RE: Drainage Strategy for Residential Development at Old Water Hall, Mirfield

We write further to the LLFA response dated 31 December 2025. The indicative layout has been updated to address the flood risk and drainage points raised.

< screenshot of the Yorkshire Water Records showing the existing surface water sewer.

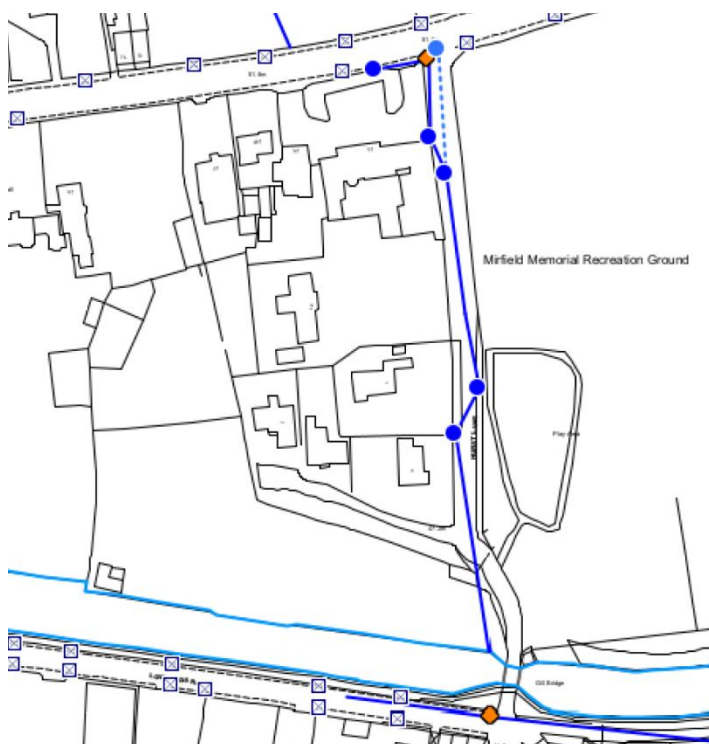
There are two realistic outfall options shown on the updated plan. First, the Yorkshire Water statutory sewer records show the existing 450mm surface water sewer to the west.

We can confirm the position shown on that record aligns with the outlet visible on site, this is shown on the photo below.
